CITY OF FORT PIERCE

**Re: Technical Review – O'Reilly Autoparts Store
S. US Highway 1**

The following are comments from the Planning Department's review of the application for Site Plan & Design Review:

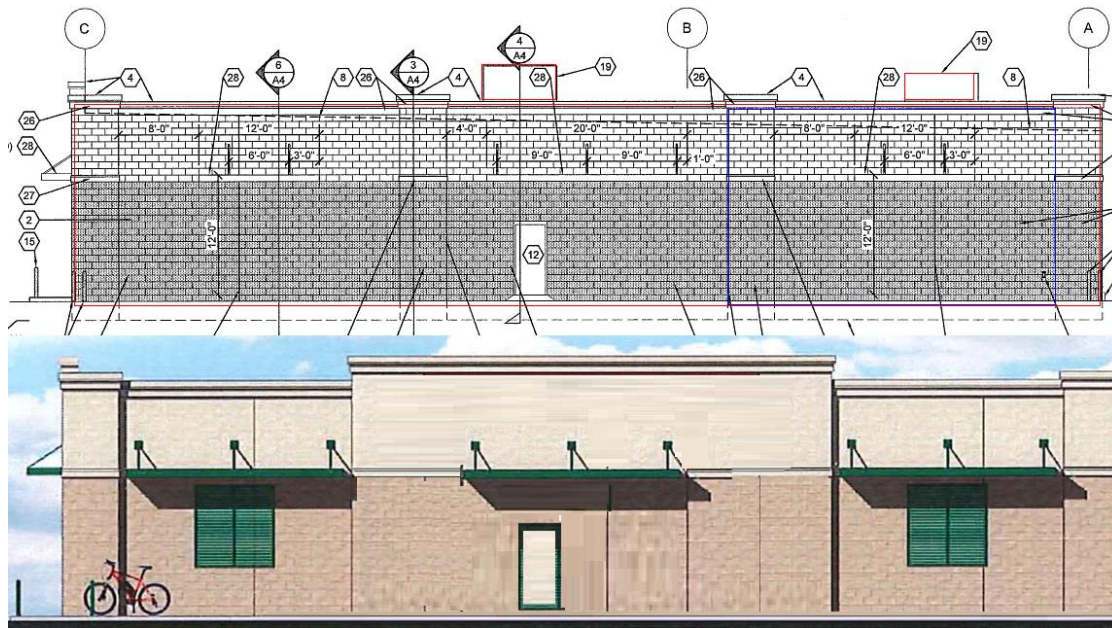
1) Pursuant to City Code Section 22-59(g)(4), please update the elevations to comply with the following guidelines:

c. Articulation in the facade should give visual relief and be of sufficient depth to provide shade and shadow on adjacent building surfaces. Colors of wall surfaces shall be chosen to complement this facade articulation and colors shall be in keeping with the chosen architectural style and character.

k. Blank walls are discouraged. Walls shall be punctuated with windows, doors or architectural elements. New construction that includes long dimensions of continuous wall shall employ the use of site breaks to punctuate the streetscape.

A conceptual mark-up of the façade(s) are presented below to provide guidance for some of the prospective enhancements:

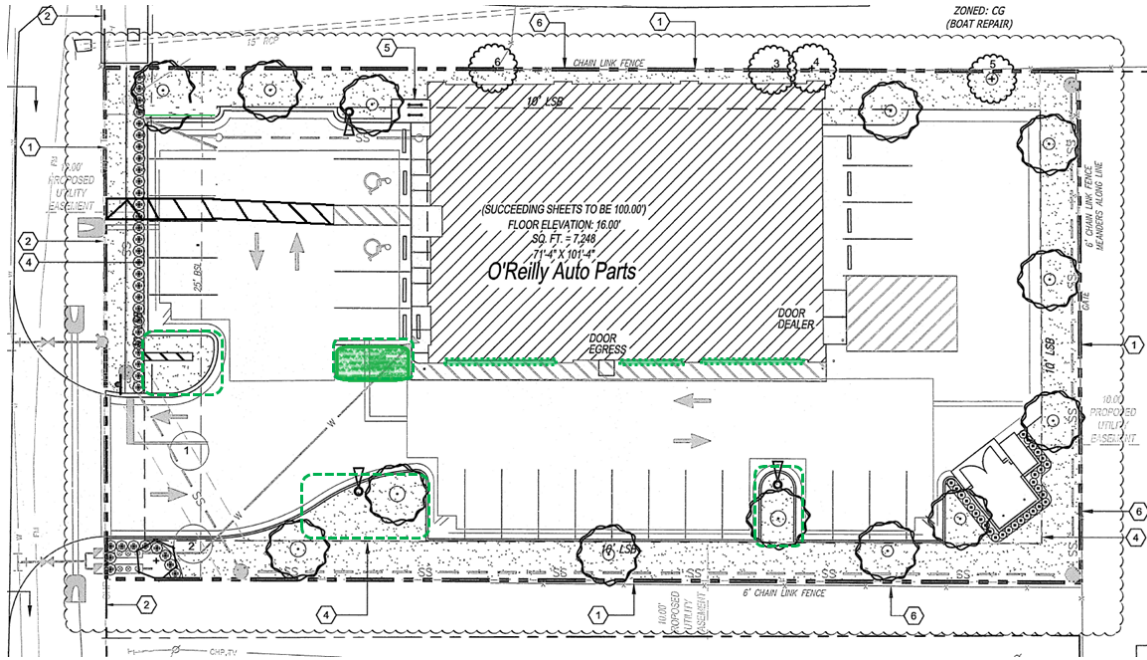
In order to utilize the exemptions to Interior landscaping area offered, the preserved trees must be located within the vehicular use area. It's further noted that "the total amount of the interior landscaped area is (may) not (be) reduced by more than fifty (50) per cent." A 700 exemption is not applicable due to 1) The preserved trees being along the northern property line, not within the interior vehicular use area, and 2) The requested exemption is more than a 50% reduction in the overall required amount of 1,171 sq. ft

Please revise the landscape accordingly. A few potential options are presented below:

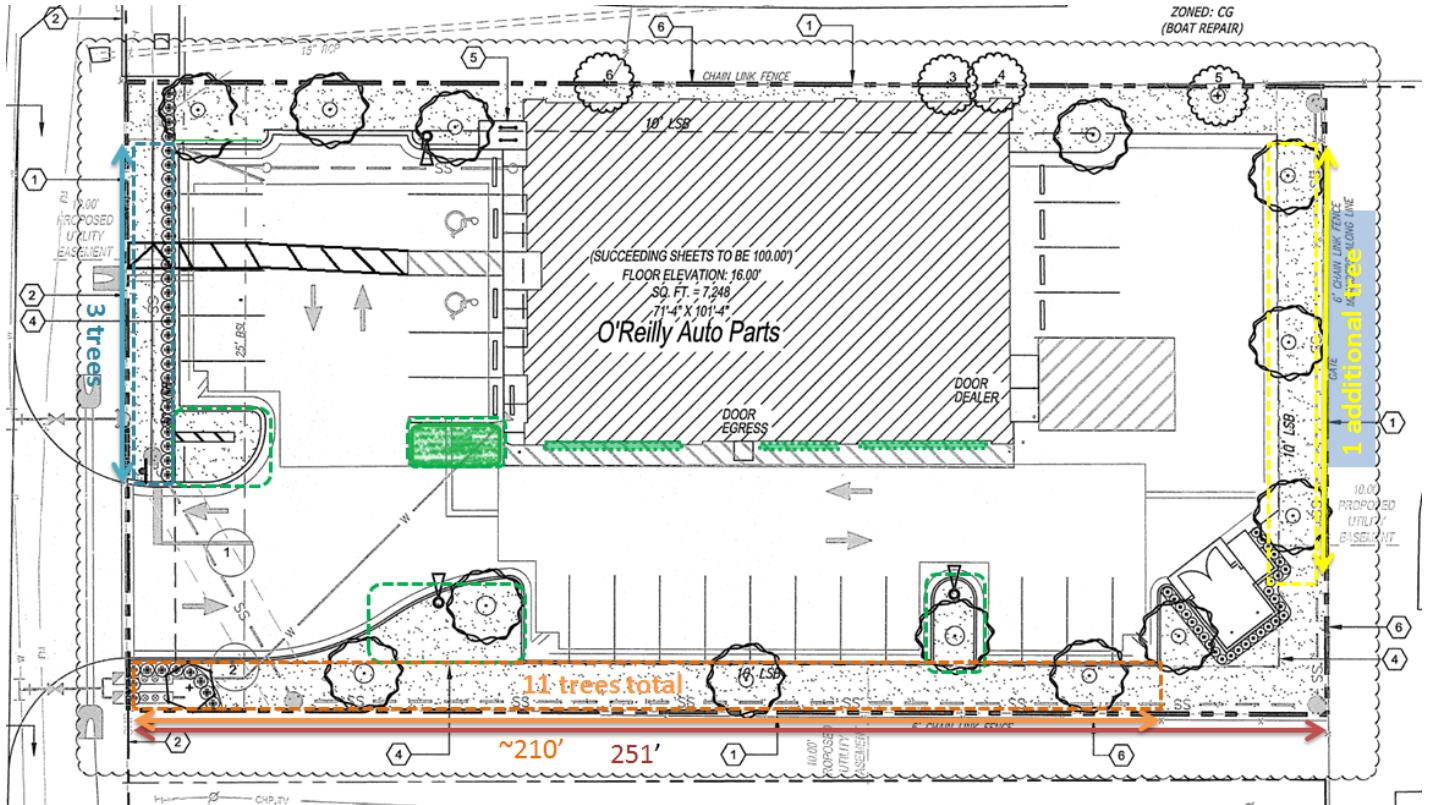
3) Pursuant to City Code Section 22-62. - Sidewalks. (d) (2) and Florida Accessibility Code, a sidewalk connection from the building entrance to the adjacent US Highway 1 ROW is required. As discussed, payment in-lieu of providing the sidewalk along US Highway 1 will be required.
